Project	IEEE 802.16 Broadband Wireless Access Working Group < http://ieee802.org/16 >	
Title	H-ARQ MAC Support for MIMO OFDMA	
Date Submitted	2004-08-31	
Source(s)	<p>Wonil Roh, Geunhwi Lim, Jaehee Cho, JeongTae Oh, Chan-Byoung Chae, Kyunbyoung Ko, Hongsil Jeong, Sung-Ryul Yun, Seungjoo Maeng, Panyuh Joo, Jaeho Jeon, Yong Chang, TaeWon Kim, Jaeyeol Kim, Soonyoung Yoon, Inseok Hwang</p> <p>Samsung Electronics Co., Ltd.</p> <p>David Garrett, Brett Schein, Erik Lindskog, Kamlesh Rath, K. Giridhar, Aditya Agrawal, B. Sundar Rajan, A. Paulraj</p> <p>Beceem Communications, Inc.</p> <p>Mark Cudak, Brian Classon</p> <p>Motorola Inc.</p>	<p>wonil.roh@samsung.com</p> <p>Voice: +82-31-279-3868</p> <p>dgarrett@beceem.com</p> <p>Voice: +1-408-387-5014</p> <p>Mark.Cudak@motorola.com</p> <p>Voice: +1-847-576-2573</p>
Re:	Contribution supporting TGe WG ballot #14c	
Abstract	H-ARQ MAC Support for MIMO OFDMA	
Purpose	Adoption of proposed changes into P802.16e

IEEE C802.16e-04/163r6

H-ARQ MAC Support for MIMO OFDMA

Figure 1 Downlink H-ARQ Sub-frame Structure

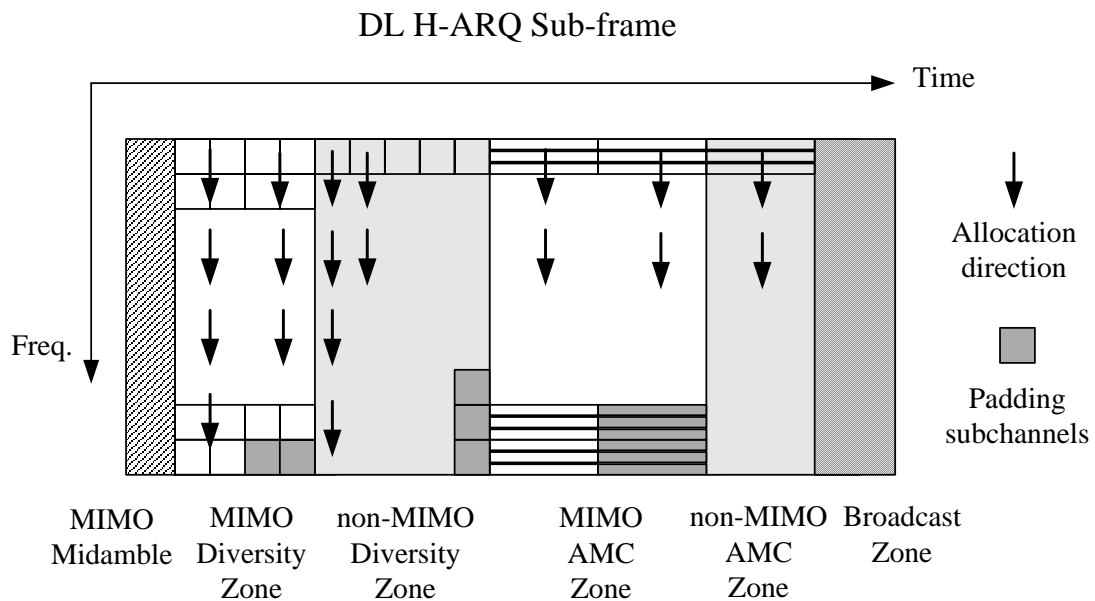
When MIMO enabled DL burst are present within a frame, they shall be allocated before non-MIMO DL burst in both diversity and AMC zones. Figure 1 exemplifies the DL H-ARQ sub-frame structure, where the optional MIMO midamble is shown and 2x3 AMC type is depicted. Both MIMO diversity and MIMO AMC zones shall contain even number of symbols. For any remaining physical resources for each zone, padding subchannels shall be allocated to the region.

Figure 2 Uplink H-ARO sub-frame Structure

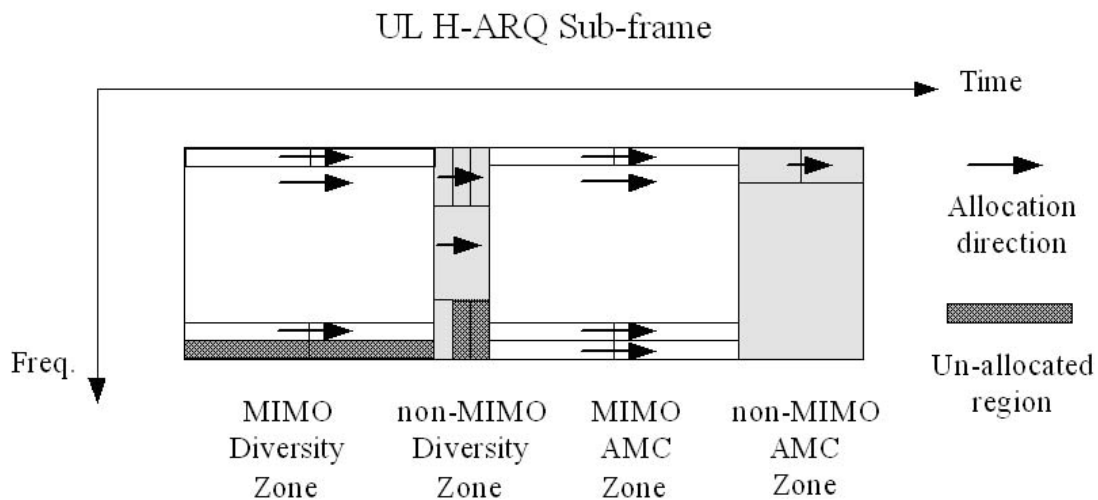
When MIMO enabled UL burst are present within a frame, they shall be allocated before non-MIMO DL burst in both diversity and AMC zones. Figure 1 exemplifies the UL H-ARQ sub-frame structure, where the 1x6 AMC type is depicted.

Within the MIMO diversity zone, subchannels shall take the form of Mini-subchannel Type 01 in Table 312, which spans over 6 symbols. Within the MIMO AMC zone, subchannels shall take 1x6 AMC type. Both MIMO diversity and MIMO AMC zones shall contain multiple of 6 symbols.
